SHINE EMBROIDERY LTD

198 Gajirchat, Modhapara, Ashuliya, Savar, Dhaka
(23.935846, 90.281109)

5 March 2024

Figure 3.8.3: Deflected shape of the building.

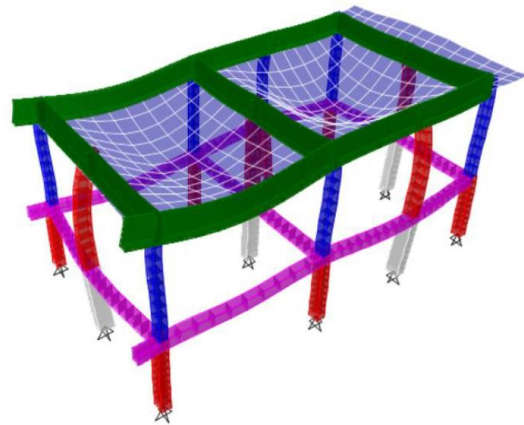
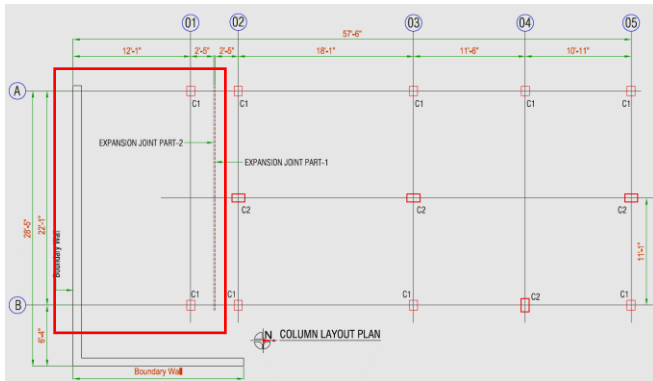
Observation-3: Inconsistencies in design report. (Security Building)

Description: In security building there are two parts, separated by an expansion joint. But in the design report only one part was considered, red marked part was not considered.

The building engineer is required to revise the design documents considering the inconsistencies and submit the documents to RSC for review.
